INDESIT company

Model type:
IDL42EU

Commercial code:
F030419

Notices

N1045072FIG1

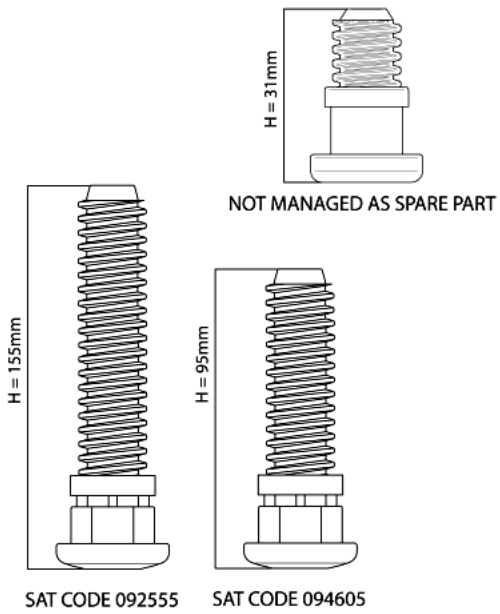
N1045072: Introduction of fixed rear foot H=31mm on free-standing models.

From serial no. 40218.0001, free-standing dishwashers affected by this modification have been equipped with new fixed rear feet (H=31mm).
The new foot replaces the adjustable one (H=155mm) Service code 092555; on the EVO3 range with TurboDry the new foot replaces the adjustable foot (H=95mm) Service code 094605.
The Spare Part Warehouse will continue to manage only 155mm and 95mm adjustable feet as they are interchangeable with the fixed 31mm foot.
The three feet are shown in illustration N1045072FIG1.

n1045085: Introduction of new litre counter turbine integrated on air-break.

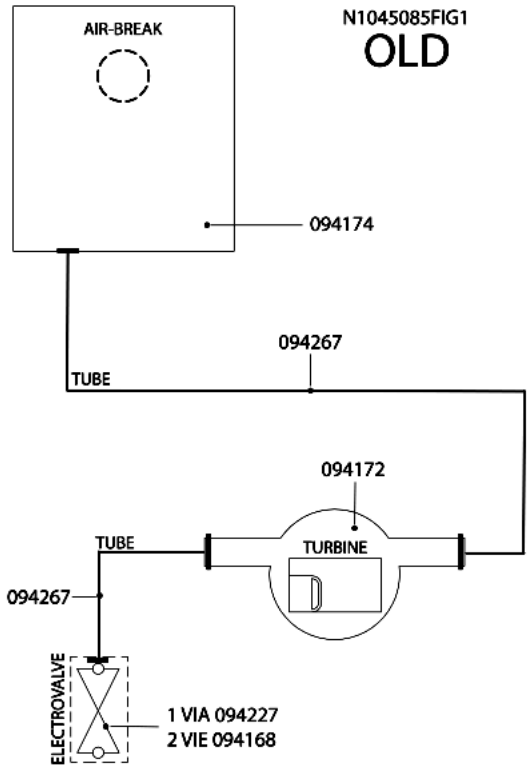
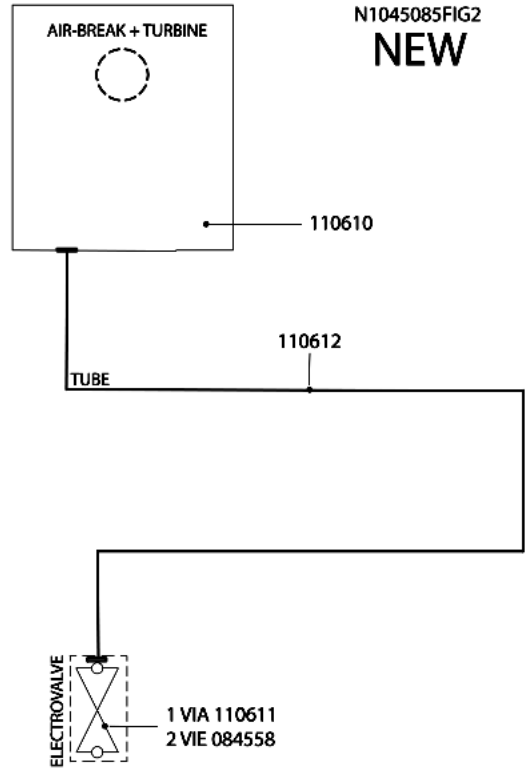
All dishwashers affected by this note have been equipped with a new litre counter turbine on the air-break.
Picture N1045085FIG1 illustrates the premodification structure, picture N1045085FIG2 the new structure.

Items affected by the modification.

AIR-BREAK:
new 110610;
premodification 094174;
the new item features a new integrated litre counter turbine and its water supply hose has a smaller diameter.

LITRE COUNTER TURBINE code 094172 has been eliminated.

SOLENOID VALVES:
new:
1-WAY code 110611;
2-WAY code 084558(Rohs 143737);
premodification:
1-WAY code 094227;
2-WAY code 094168;
the new solenoid valves have a smaller diameter drain hose fitting.

HOSES:
new solenoid valve hose/air-break code 110612;
premodification turbine hose/air-break code 094267;
premodification solenoid valve hose/air-break code 094267;
the new hose has a smaller internal diameter.

WIRING:
the litre counter turbine connecting cable is longer, but since the connector is the same, the new item can be used in place of the premodification one.
